TXU, Comanche Peak SES, Glen Rose, Texas

Comments Regarding Draft Environmental Impact Statement for Combined Licenses (COLs) for
Comanche Peak Nuclear Power Plant Units 3 and 4
By David Power
Public Citizen's Texas Office

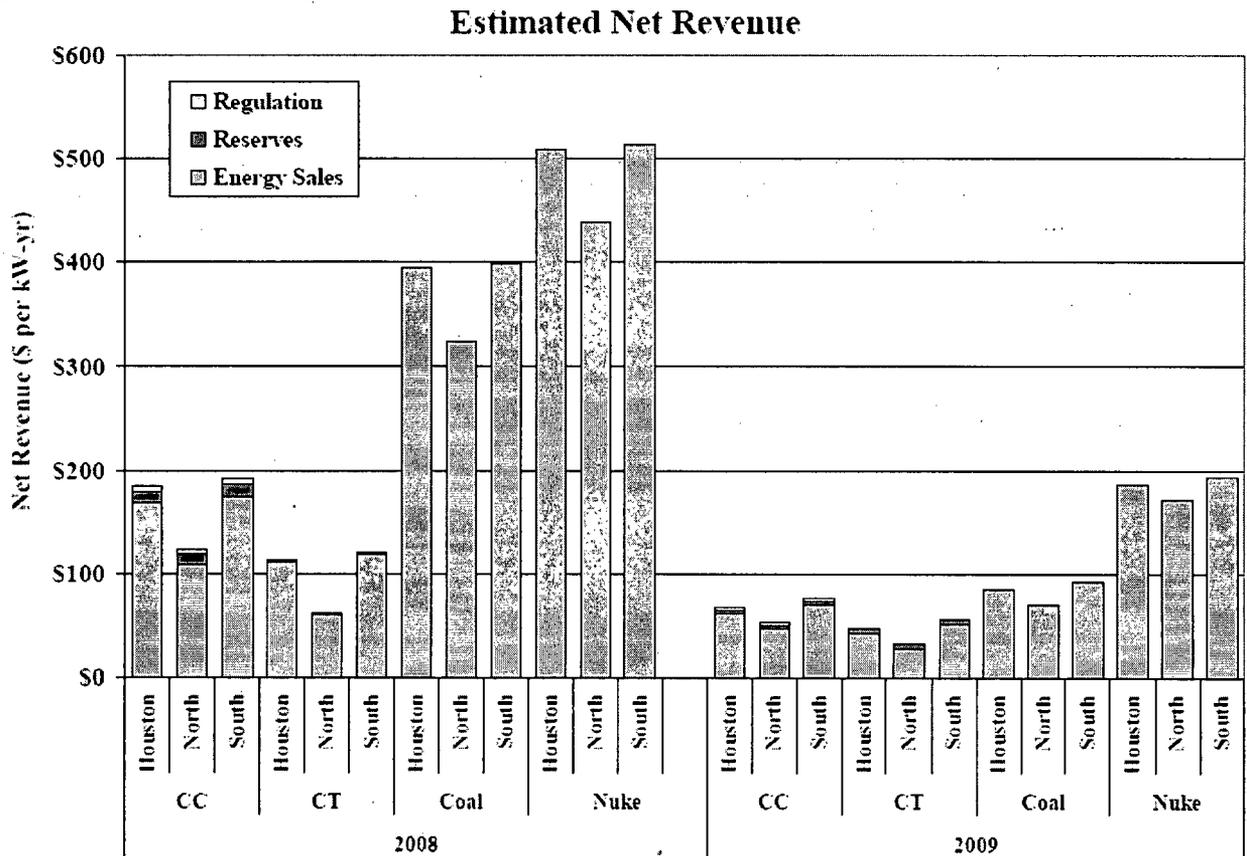
The figure above shows that the net revenue decreased substantially in 2009 compared to each zone compared in 2008. Based on our estimates of investment costs for new units, the net revenue required to satisfy the annual fixed costs (including capital carrying costs) of a new gas turbine unit ranges from \$70 to \$95 per kW-year. The estimated net revenue in 2009 for a new gas turbine was approximately \$55, \$47 and \$32 per kW-year in the South, Houston and North Zones, respectively. For a new combined cycle unit, the estimated net revenue requirement is approximately \$105 to \$135 per kW-year. The estimated net revenue in 2009 for a new combined cycle unit was approximately \$76, \$67 and \$52 per kW-year in the South, Houston and North Zones, respectively.

These values indicate that the estimated net revenue in 2009 was well below the levels required to support new entry for a new gas turbine or a combined cycle unit in the ERCOT region. Prior to 2005, net revenues were well below the levels necessary to justify new investment in coal and nuclear generation. However, high natural gas prices through 2008 allowed energy prices to remain at levels high enough to support new entry for these technologies. The production costs of coal and nuclear units did not change significantly over this period, leading to a dramatic rise in net revenues. With the significant decline in natural gas and energy prices in 2009, these results changed dramatically from recent years. For a new coal unit, the estimated net revenue requirement is approximately \$190 to \$245 per kW-year. The estimated net revenue in 2009 for a new coal unit was approximately \$93, \$84 and \$70 per kW-year in the South, Houston and North Zones, respectively. For a new nuclear unit, the estimated net revenue requirement is approximately \$280 to \$390 per kW-year. The estimated net revenue in 2009 for a new nuclear unit was approximately \$194, \$187 and \$172 per kW-year in the South, Houston and North Zones, respectively. These values indicate that the estimated net revenue for a new coal and nuclear unit in the South, Houston and North Zones was well below the levels required to support new entry in 2009. “ This calls into question the validity of the NRC staff’s determination on 8-1 line 43 that market conditions justify Luminant’s proposal.

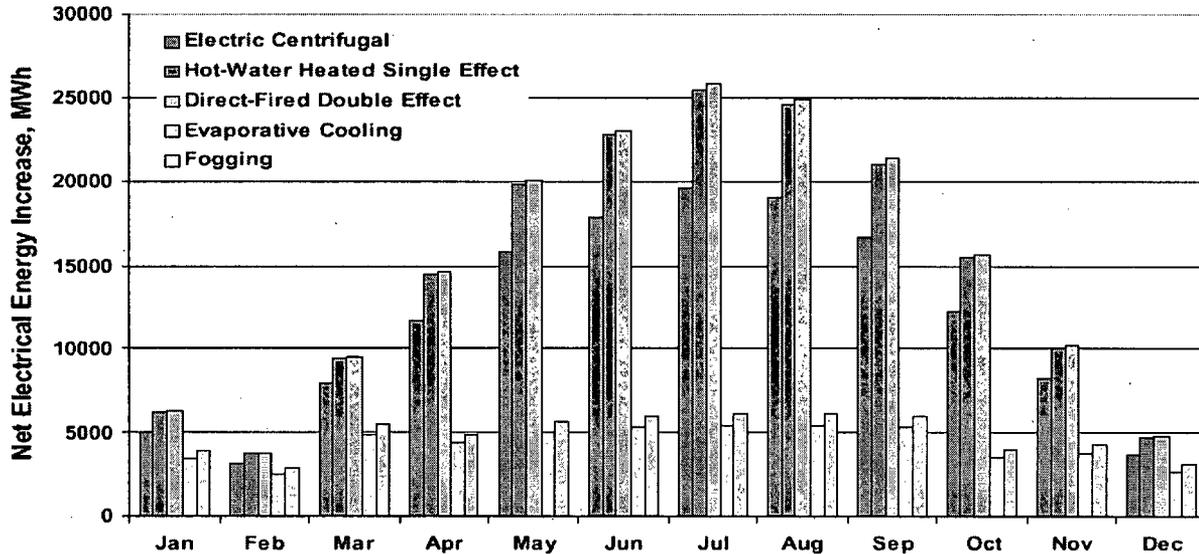
- 3) Underestimating the continued growth of the wind generation market in Texas: at page 9-21, lines 3 thru 8, Luminant concluded that it would take more than 10,000 MW of wind to replace the base load capacity provided by the proposed CPNPP units 3 and 4. Texas has now “officially” exceeded the 10,000 MW of installed wind capacity threshold (with 10,030 MW) based on information on ERCOT’s Renewable Energy Credit (REC) Program website⁵. Texas has already exceeded the goals set for its renewables program for the year 2025.

Based on this information there is currently enough wind power alone to provide the necessary

capacity according to Luminant's calculations.

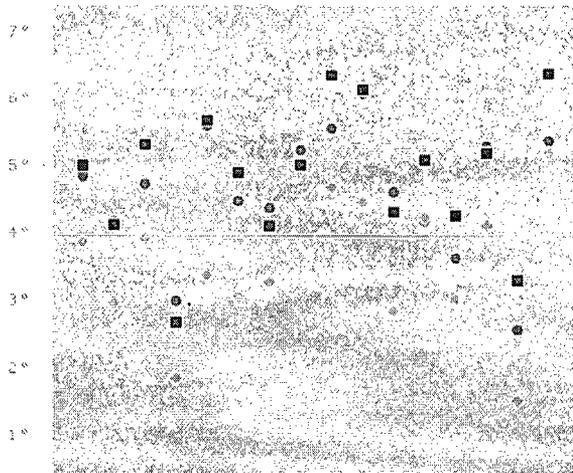
A recent study on Comanche Peak examined the impact of high cooling water temperatures and found when temperature exceed 95 plant production decreased and above 101 F required shut down. Supplemental cooling water systems were not cost effective!

For the simulation year chosen, intake temperatures exceeded 95 F more than 80 days. Plant production decreases once the intake temperature goes above 95 F and ultimately needs to be shut down at 101 F when the condenser pressure reaches 5.0 in. HgA

Change in Annual Temperature by the 2050s

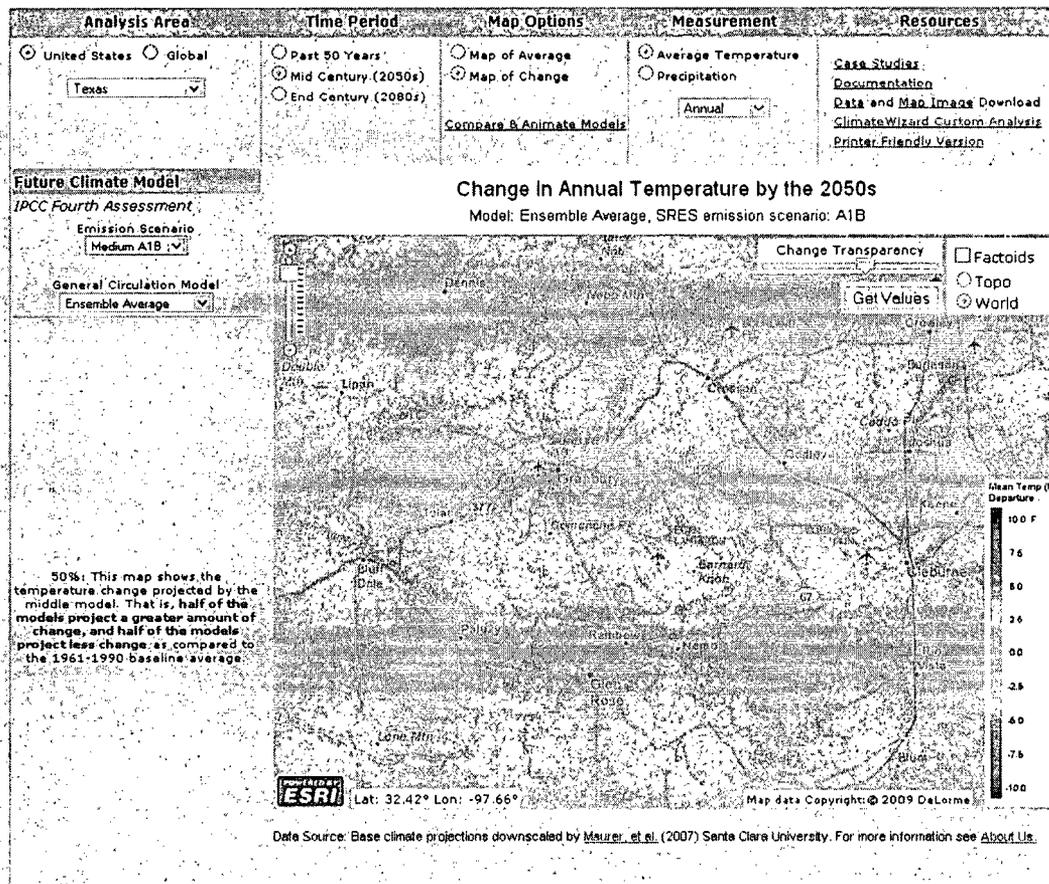
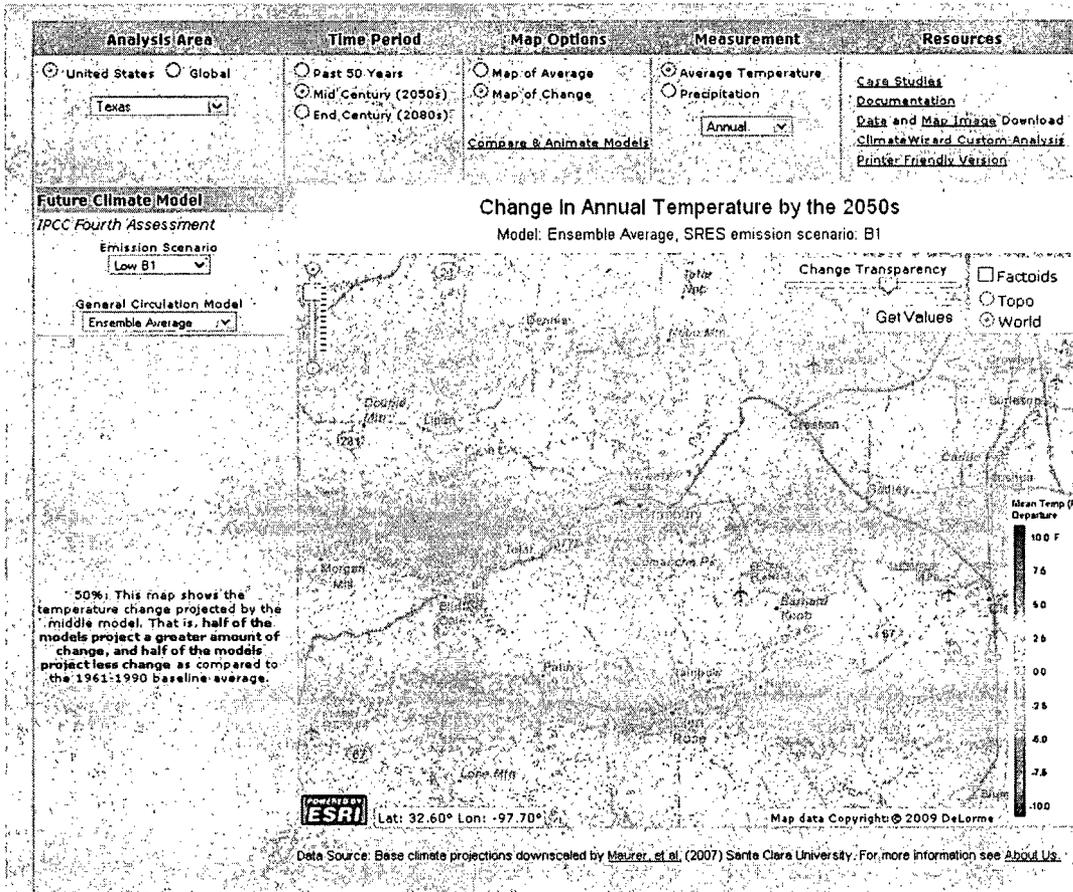
Using the analysis from The Nature Conservancy based on the IPCC's Fourth Assessment Report at <http://www.ClimateWizard.org>, we find that likely temperature changes within the expected operating life of the plant to be in excess of 6 degrees (f). Add that to the average current high temperatures on Lake Granbury and the plant will likely have to curtail generation and may not be able to operate without constraint several months each summer.

The maps and regression models provided by Climate Wizard are attached at pp.6-7.

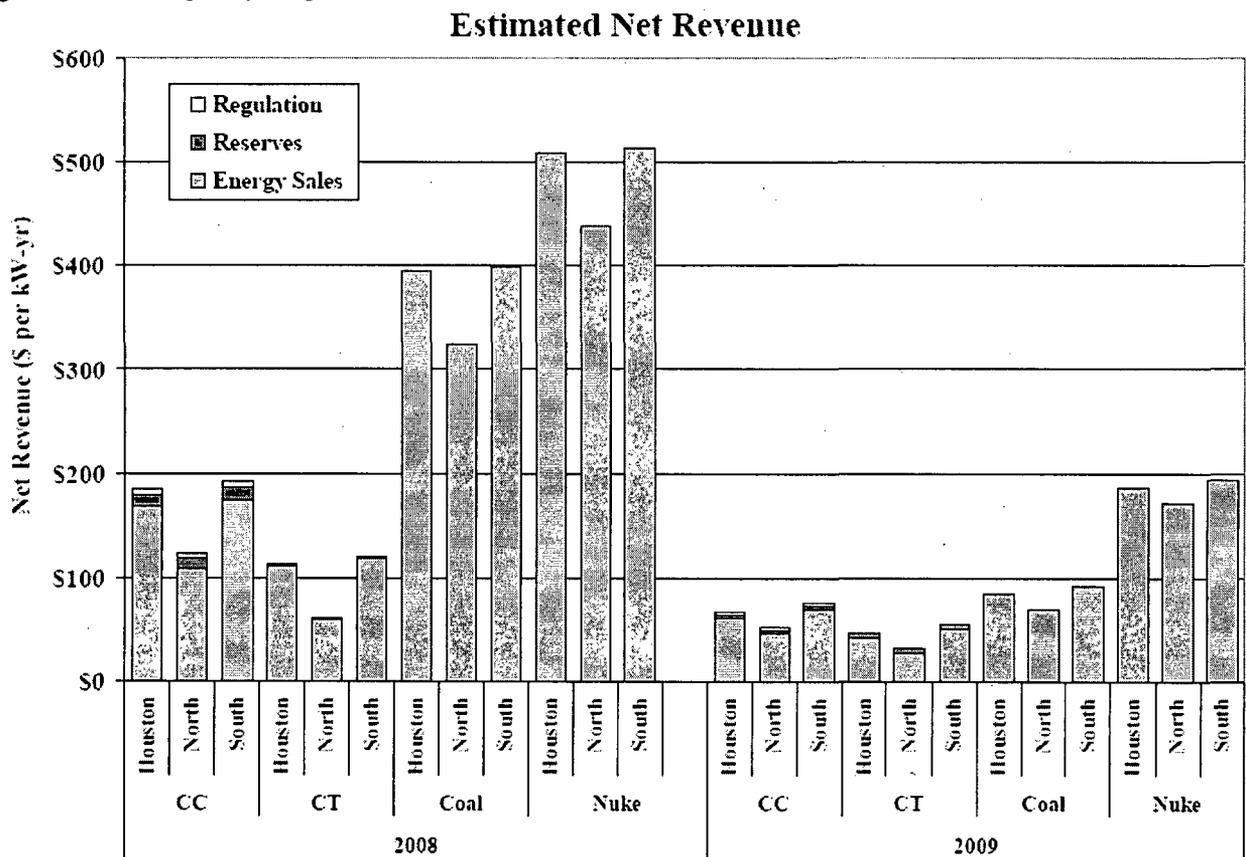
The figure above shows that the net revenue decreased substantially in 2009 compared to each zone compared in 2008. Based on our estimates of investment costs for new units, the net revenue required to satisfy the annual fixed costs (including capital carrying costs) of a new gas turbine unit ranges from \$70 to \$95 per kW-year. The estimated net revenue in 2009 for a new gas turbine was approximately \$55, \$47 and \$32 per kW-year in the South, Houston and North Zones, respectively. For a new combined cycle unit, the estimated net revenue requirement is approximately \$105 to \$135 per kW-year. The estimated net revenue in 2009 for a new combined cycle unit was approximately \$76, \$67 and \$52 per kW-year in the South, Houston and North Zones, respectively.

These values indicate that the estimated net revenue in 2009 was well below the levels required to support new entry for a new gas turbine or a combined cycle unit in the ERCOT region. Prior to 2005, net revenues were well below the levels necessary to justify new investment in coal and nuclear generation. However, high natural gas prices through 2008 allowed energy prices to remain at levels high enough to support new entry for these technologies. The production costs of coal and nuclear units did not change significantly over this period, leading to a dramatic rise in net revenues. With the significant decline in natural gas and energy prices in 2009, these results changed dramatically from recent years. For a new coal unit, the estimated net revenue requirement is approximately \$190 to \$245 per kW-year. The estimated net revenue in 2009 for a new coal unit was approximately \$93, \$84 and \$70 per kW-year in the South, Houston and North Zones, respectively. For a new nuclear unit, the estimated net revenue requirement is approximately \$280 to \$390 per kW-year. The estimated net revenue in 2009 for a new nuclear unit was approximately \$194, \$187 and \$172 per kW-year in the South, Houston and North Zones, respectively. These values indicate that the estimated net revenue for a new coal and nuclear unit in the South, Houston and North Zones was well below the levels required to support new entry in 2009. “ This calls into question the validity of the NRC staff’s determination on 8-1 line 43 that market conditions justify Luminant's proposal.

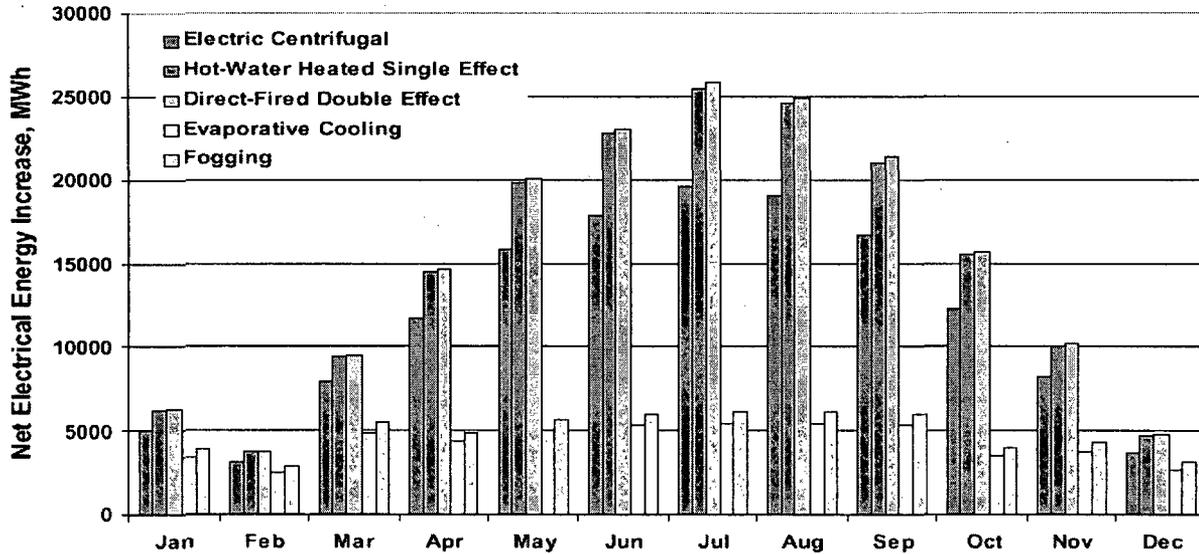
- 3) Underestimating the continued growth of the wind generation market in Texas: at page 9-21, lines 3 thru 8, Luminant concluded that it would take more than 10,000 MW of wind to replace the base load capacity provided by the proposed CPNPP units 3 and 4. Texas has now “officially” exceeded the 10,000 MW of installed wind capacity threshold (with 10,030 MW) based on information on ERCOT’s Renewable Energy Credit (REC) Program website⁵. Texas has already exceeded the goals set for its renewables program for the year 2025.

Based on this information there is currently enough wind power alone to provide the necessary

capacity according to Luminant's calculations.
